Petition No. 1737

REQUEST ENCROACHMENT
 A PORTION OF THE EAST/WEST PUBLIC ALLEY
 (With Emergency Blue Phone, Duckwork,
 Exhaust Fan and Bollards)
 AND INTO E. FORT AND BRUSH ST.
 (With Architectural Elements, Signs, Lighting,
 Canopies, etc... 8' Above Grade to Top of Building)
 AT 407 E. FORT ST.

CITY OF DETROIT CITY ENGINEERING DEPARTMENT SURVEY BUREAU	
JOB NO.	01-01
DRWG. NO.	X 1737

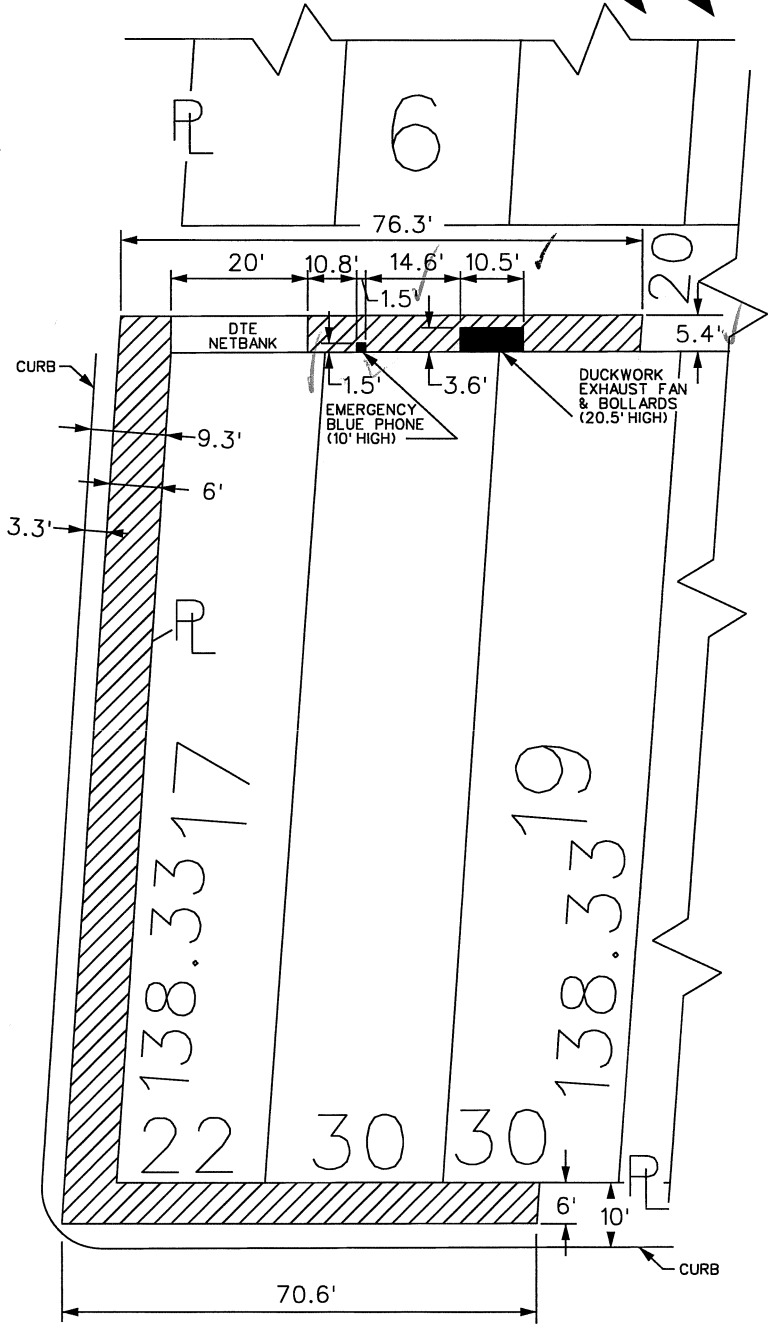
- (X) Involved, have no objection to the request to encroachment a portion of the east/west public alley (With Emergency Blue Phone, Duckwork, Exhaust Fan and Bollards) at 407 E. Fort St. as shown on drawing no. x1737 dated 10/03/2017 provided that 100% signatures of abutting property owners are secured. However, we **have objection** to the request for encroachment into a portion of the east/west public alley ,Fort St and Brush St. (With Architectural Elements, Signs, Lighting, Canopies, etc...8' above Grade to Top of Building) at 407 E. Fort St. as shown on drawing no. x1737 dated 10/03/2017 since the dimensions/clearances of the proposed awning do not comply with Sec. 61-14-292 of the Detroit Zoning Ordinance.
